Service Bulletin No: 27-015

Modification No: EC-19-0142

**FLIGHT CONTROLS - ROLL CONTROL
INTRODUCTION OF A FIXED AILERON TAB INSTALLATION**

Measurement of the Aileron Trim-Tab Deflection
Figure 1

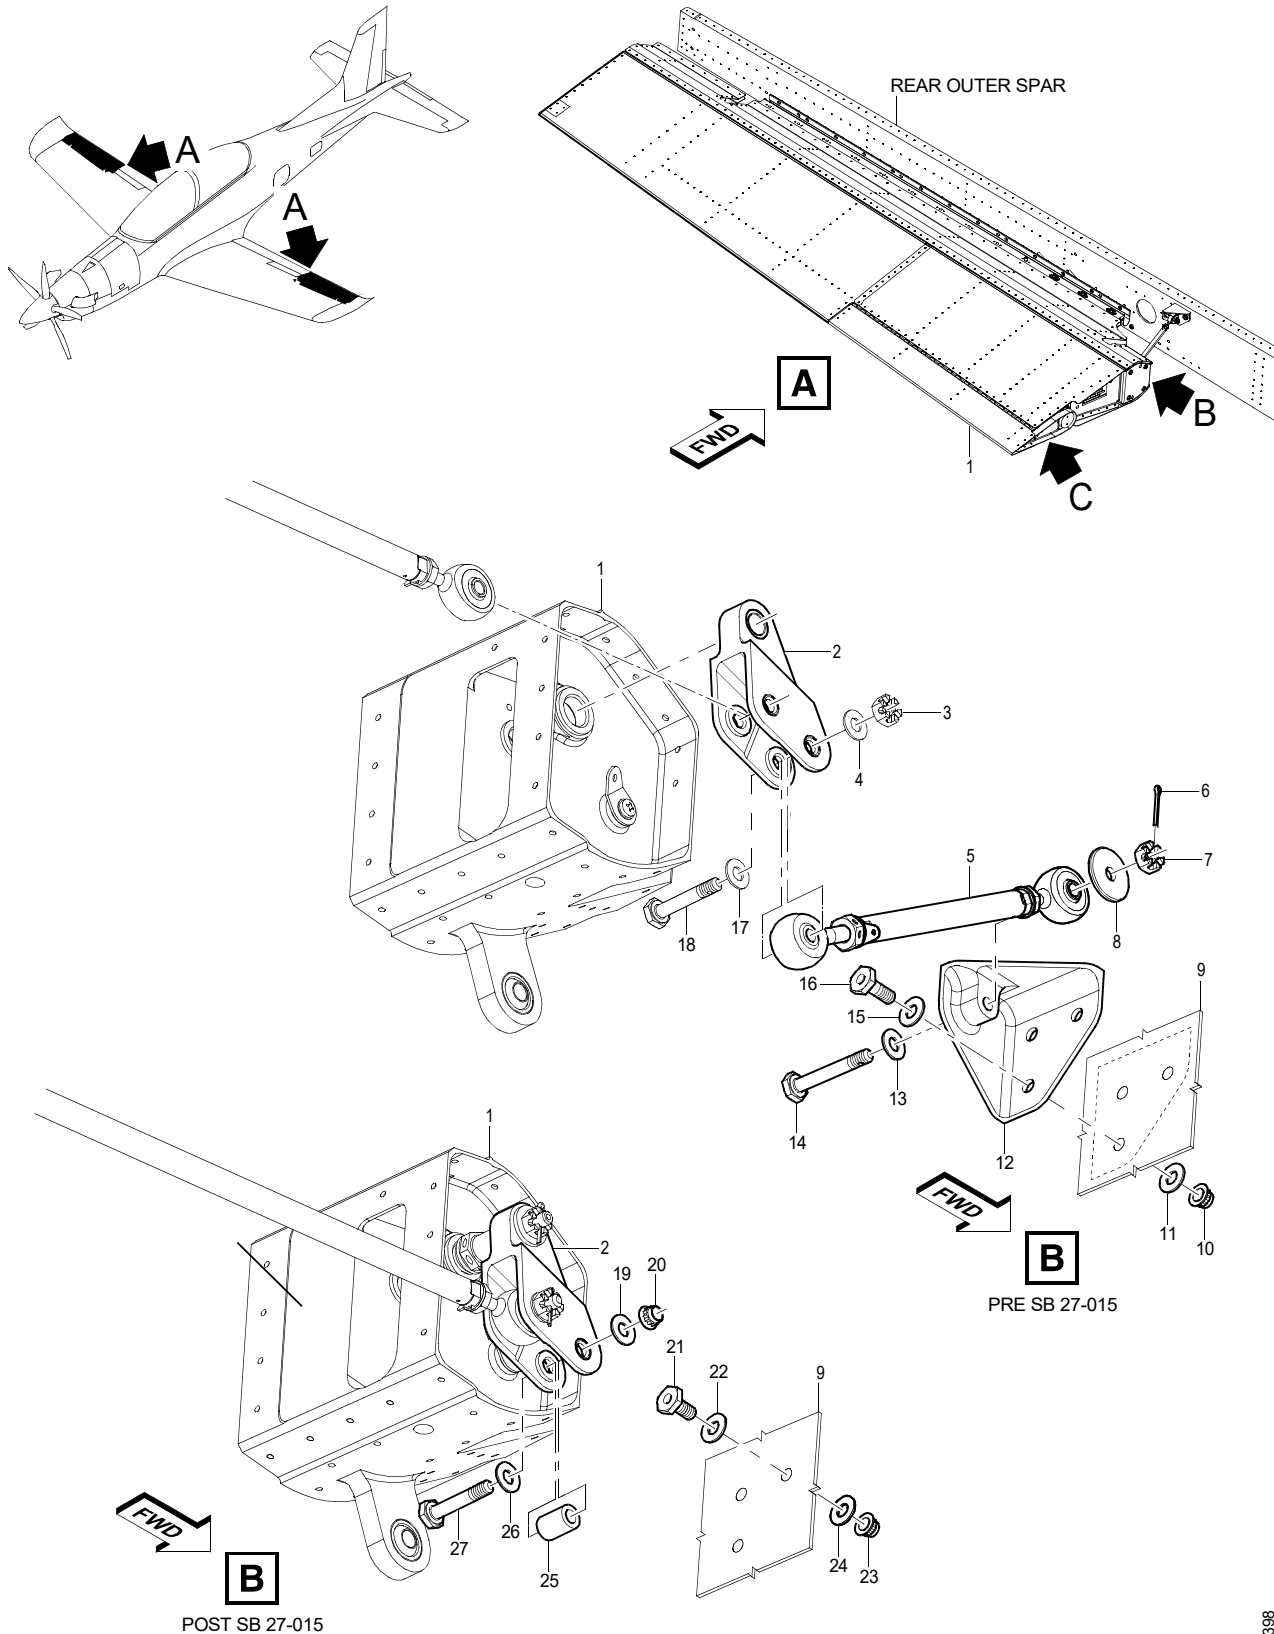
- (1) Do the safety procedures for the Flight Control System (FCS), before you do work on the flight controls (Ref. AMM, 27-00-00-00A-012A-A).
- (2) Put a warning sign 'DO NOT OPERATE THE FLIGHT CONTROLS', in the front cockpit and the rear cockpit.
- (3) Do the procedure to measure the aileron tab deflection (Ref. Fig. 1).

- (a) Install the aileron trim control rigging-pin (Ref. AMM, 27-10-03-00A-344A-A).
- (b) Use a straight edge (A ruler held on its edge or equivalent) and hold it in position on the upper surface of the aileron (2) or tab (1) as follows:
 - If the tab (1) is deflected above the aileron (2), hold straight edge (4) on the tab (1)
 - If the tab (1) is deflected below the aileron (2), hold straight edge (4) on the aileron (2).
- (c) Use a pencil (or equivalent) to make a mark on the relevant surface where you hold the straight edge (4).
- (d) Use a feeler gauge (or equivalent) and measure the gap between the underside of the straight edge (4) and the relevant surface (the aileron (2) or the tab (1)).

- (e) Make record of the left and right measurements as follows:
- Assign a positive value (+) when the measurement of the tab is above the aileron
 - Assign a negative value (-) when the measurement of the tab is below the aileron.
- NOTE:** You will use these measurements to set the aileron tabs to the correct system trim position when you fix the tabs to the ailerons.
- (f) Remove the aileron trim control rigging-pin (Ref. AMM, 27-10-03-00A-344A-A).
- (4) Remove the left and right aileron assemblies (Ref. AMM, 27-10-04-00A-520A-A).
- (5) Examine the aileron tab main-rib on the LH and RH ailerons. If any structural damage is found, please contact Pilatus for guidance.

- ① MEASURE THE DISTANCE BETWEEN THE AILERON (2) AND THE TAB (1).
- ② SHOWN WITH TAB (1) DEFLECTED ABOVE THE AILERON (2), IT IS POSSIBLE FOR THE TAB (1) TO BE DEFLECTED BELOW THE AILERON (2).

Modification to Introduce a Fixed Aileron Trim Tab Installation
Figure 2 (Sheet 1 of 2)

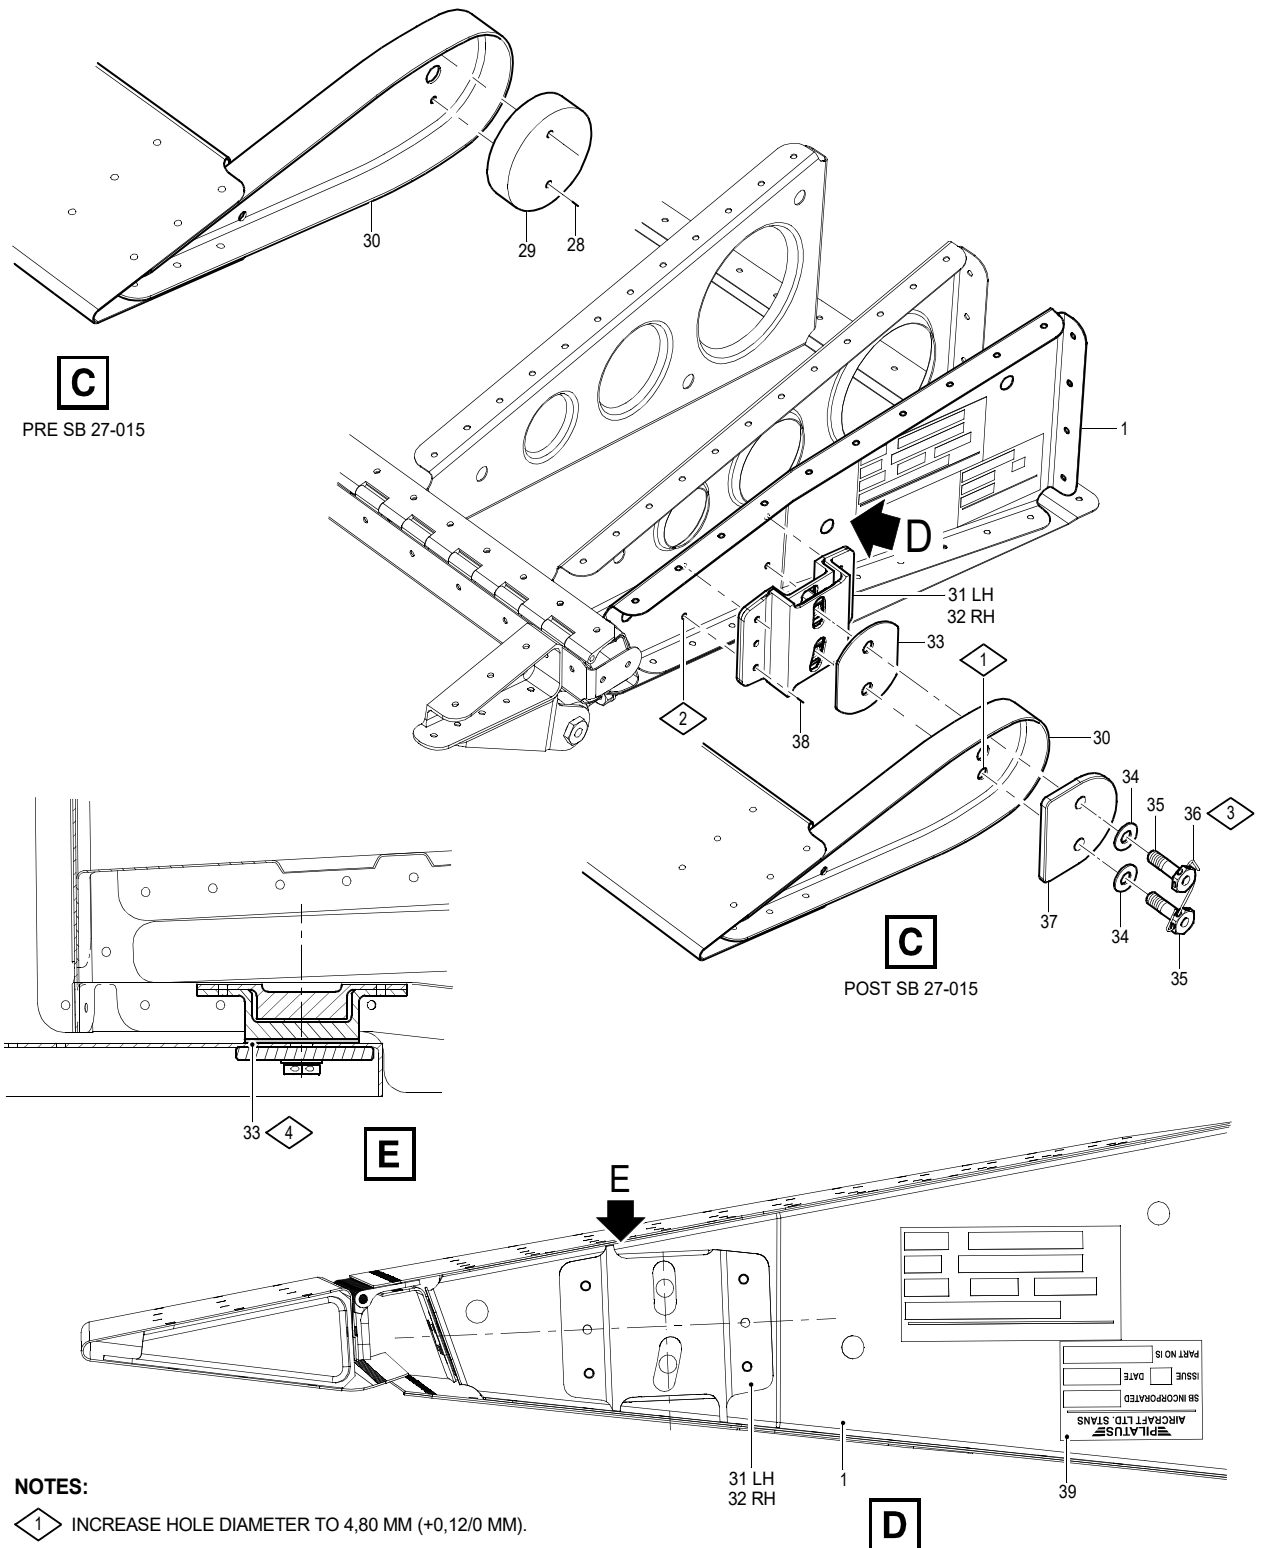
During flutter analysis of under wing stores configurations, it was found that the failure case with disconnected aileron Flettner tabs shows a dynamic instability within the flight envelope for all aircraft configurations.

The aileron Flettner tabs are clamped mechanically to the LH and RH ailerons to make sure that they do not become disconnected in flight. As a result, the Flettner tab functionality is lost.

This Service Bulletin gives the instructions and data necessary to clamp the Flettner tabs to the ailerons and remove the input rods on the left and right sides.

- (1) Do the modification to remove the trim tab input mechanism.
- (a) Remove the trim tab pushrod (5) and the trim tab bracket (12).
- 1 Remove and discard the cotter pin (6).

- (a) Remove the tab balance weight (29).
- 1 Use a 3,2 mm diameter drill and carefully remove the two rivets (28) from the balance weight (29).
 - 2 Remove and discard the balance weight (29) from the aileron trim tab assembly (30).
 - 3 If necessary, use a non-metallic scraper to remove any residual sealant from the work area.
 - 4 Use absorbent paper (Material No. P02-031) made moist with solvent (Material No. P01-010) to clean the work area.
- (b) Increase the diameter of the holes in the aileron trim tab assembly (30) for the attachment of the new ballast weight (37) (Pos. No. 45).
- 1 Use a 4,80 mm (+0.12/0 mm) diameter drill and increase the diameter of the old rivet holes in the aileron trim tab assembly (30) to make the new bolts holes.
 - 2 Apply a chamfer to the new bolts holes of between 0,20 mm and 0,40 mm.

- 3 Apply a layer of alodine 1132 (Material No. P07-021) to the bolt holes in the aileron trim tab assembly (30).
 - 4 Apply a layer of the primer (Material No. P07-007) to the bolt holes in the aileron trim tab assembly (30).
- (c) Install the new clamping device (31) (Pos. No. 10) (LH) (or (32) (Pos. No. 20) (RH)) on the aileron assembly (1).
- 1 Put the clamping device (31) (Pos. No. 10) (LH) (or (32) (Pos. No. 20) (RH)) on the aileron assembly (1), hold it in position and make sure of the following:
 - With the trim tab assembly (30) in the neutral position, the bolts holes for the ballast weight align with the corresponding attachment holes in the clamping device (31) (Pos. No. 10) (LH) (or (32) (Pos. No. 20) (RH)).
 - The three spigots points of the clamping device (31) (Pos. No. 10) (LH) (or (32) (Pos. No. 20) (RH)) are in contact with the structure of the aileron assembly (1)

- 1 INCREASE HOLE DIAMETER TO 4,80 MM (+0,12/0 MM).
- 2 DRILL FOUR HOLES, 3,30 MM DIAMETER.
- 3 USE LOCKWIRE (MATERIAL NO. P02-001)
- 4 ADJUST THE SHIM PLATE AS NECESSARY TO REMOVE COMPRESSION DURING INSTALLATION.
